Unicorn Sweaters Ltd. Extension Building

Gorat, Navana Village, Ashulia Dhaka.
(23.94605, 90.30167)

19th October 2021

Observations

Pile & Isolated foundation layout plan

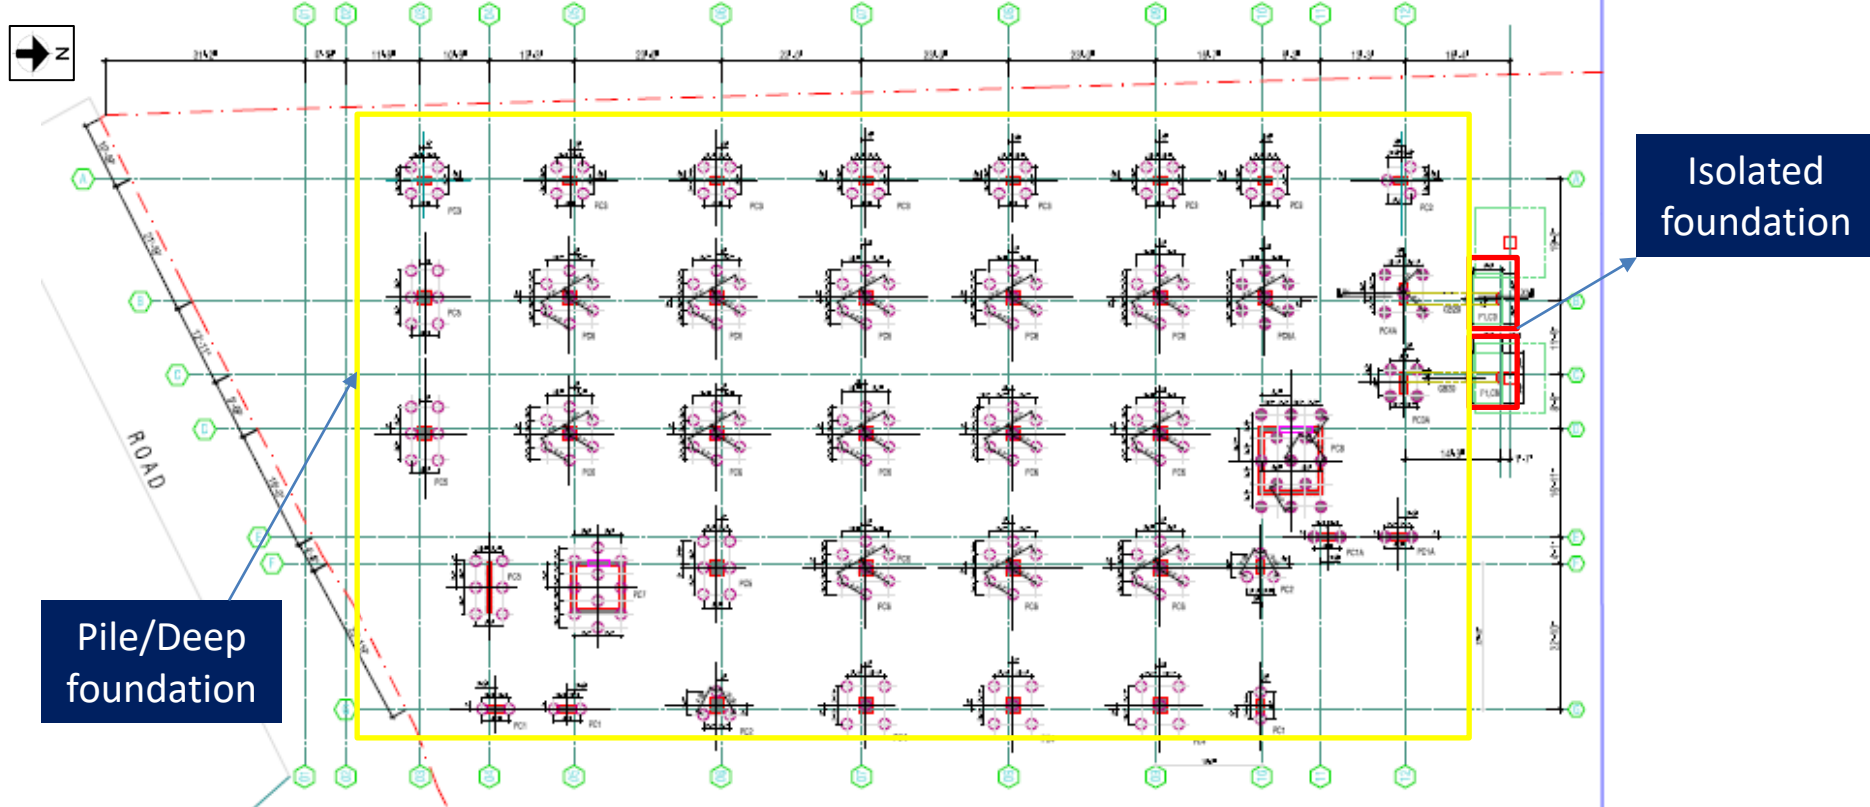
Isolated footings are stressed above normal design limit

The cursory calculation indicates that footings are stressed above the normal design limit considering the soil bearing capacity recommended in the geotechnical investigation reports. These footings are under the 2m high Over Head Water Tank. Building engineer is required to review the foundation stresses of the area identified above.

Shallow and Deep foundations are constructed and connected with the beams. Building engineer is required to check the differential settlement issue for the deep and shallow foundation.

Roof layout plan

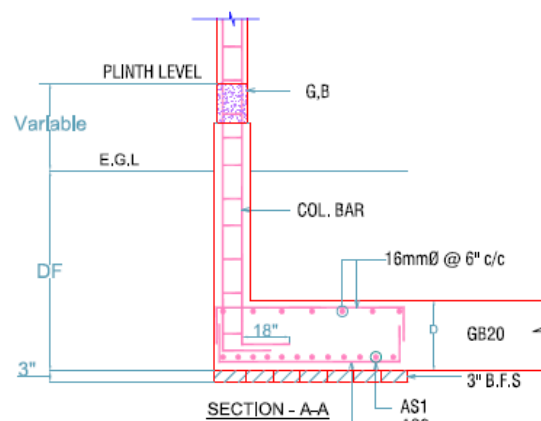
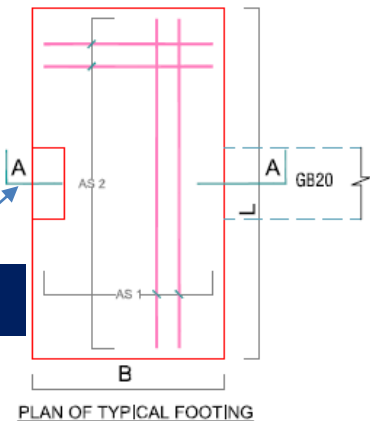
Eccentric footing was constructed but no calculation was provided in the design report. Building engineer is required to review the design of the eccentric footing and need to address it in the design report.
